Access Compliance Report

Public Rights-of-Way

(Curb Ramps)

Intersection ID: 48998	Main Street: FALLON_FARM_RD	Cross Street: STEELECROFT_PY	Location: SW
ADA ID: 8C6604576C74	Ramp Type: Perp	Initial Pass/Fail: Fail	Overall Compliance: No Severity Score: 13.75

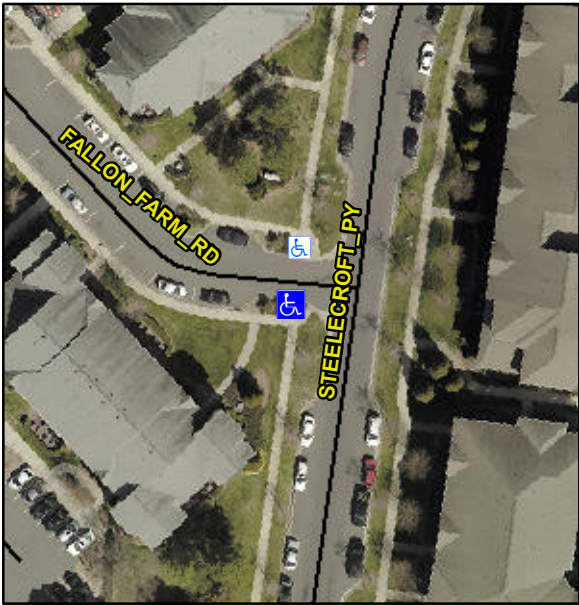
Codes/Mitigation Info/Possible Solution			Field Measurements/Component Compliance					
	Possible Solutions:		Compliance	Description	Data	Compliance	Description	Data
	Remove & Replace Entire Ramp.		N/A	Ramp Length (in)	78.0	No	Ramp Slope (%)	9.3
			Yes	Ramp Width (in)	48.0	No	Ramp XSlope (%)	3.8
			N/A	Flare Type LT	N/A	N/A	Flare Type RT	N/A
			N/A	Flare Slope LT (%)	N/A	N/A	Flare Slope RT (%)	N/A
			N/A	Flare Traversable LT?	N/A	N/A	Flare Traversable RT?	N/A
			N/A	Landing Length (in)	N/A	N/A	DWS Provided?	N/A
			N/A	Landing Width (in)	N/A	N/A	DWS Contrast?	N/A
			N/A	Landing Slope (%)	N/A	N/A	DWS Length (in)	N/A
			N/A	Landing X Slope (%)	N/A	N/A	DWS Full Width?	N/A
Surveyor Notes:			N/A	Landing Curb? (Y/N)	N/A	N/A	DWS Offset (in)	N/A
PROW/ADA:				Shared Landing?	N/A			
R304.2.2, R304.5.3				Gutter Ponding?	N/A	N/A	Gutter Slope (%)	N/A
				Gutter Lip Ht (in)	N/A	N/A	Gutter X Slope (%)	N/A
				Painted X Walk1?	No	N/A	Painted X Walk2?	N/A
